# Access Compliance Report

## Public Rights-of-Way

### (Curb Ramps)

Intersection ID: 12766	Main Street: S_GRAHAM_ST	Cross Street: W_PALMER_ST	Location: N
ADA ID: BCCBF8B244BB	Ramp Type: PerpDiag	Initial Pass/Fail: Fail	Overall Compliance: No
Severity Score: 26.25			
Codes/Mitigation Info/Possible Solution		Field Measurements/Component Compliance

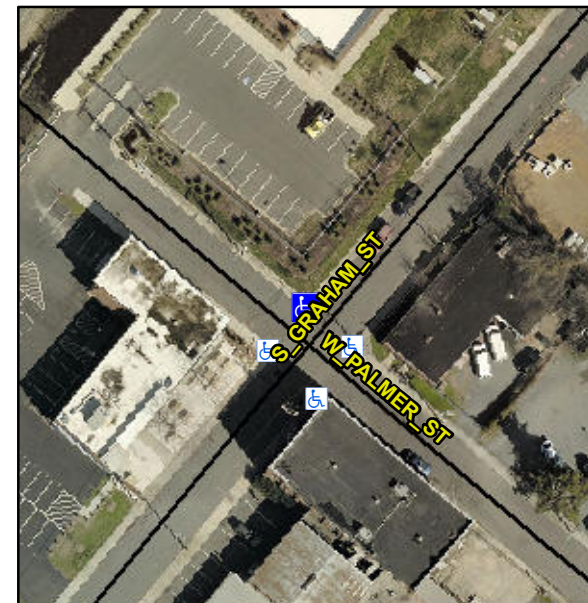
PROW/ADA:

**R304.2.2, R304.5.3**

Compliance	Description	Data	Compliance	Description	Data
N/A	Ramp Length (in)	41.0	No	Ramp Slope (%)	13.5
Yes	Ramp Width (in)	48.0	No	Ramp XSlope (%)	2.5
N/A	Flare Type LT	N/A	N/A	Flare Type RT	N/A
N/A	Flare Slope LT (%)	N/A	N/A	Flare Slope RT (%)	N/A
N/A	Flare Traversable LT?	N/A	N/A	Flare Traversable RT?	N/A
N/A	Landing Length (in)	N/A	N/A	DWS Provided?	N/A
N/A	Landing Width (in)	N/A	N/A	DWS Contrast?	N/A
N/A	Landing Slope (%)	N/A	N/A	DWS Length (in)	N/A
N/A	Landing X Slope (%)	N/A	N/A	DWS Full Width?	N/A
N/A	Landing Curb? (Y/N)	N/A	N/A	DWS Offset (in)	N/A
N/A	Shared Landing?	N/A			
N/A	Gutter Ponding?	N/A	N/A	Gutter Slope (%)	N/A
N/A	Gutter Lip Ht (in)	N/A	N/A	Gutter X Slope (%)	N/A
N/A	Painted X Walk1?	No	N/A	Painted X Walk2?	No
	X Walk 1 Direction	To SW		X Walk 2 Direction	To SE
N/A	X Walk 1 Width (in)	N/A	N/A	X Walk 2 Width (in)	N/A
	X Walk 1 Slope (%)	5.0		X Walk 2 Slope (%)	7.7
	X Walk 1 X Slope (%)	3.9		X Walk 2 X Slope (%)	1.9

Possible Solutions:

**Remove & Replace Curb Ramp With Two New Directional Ramps or Equivalent.**
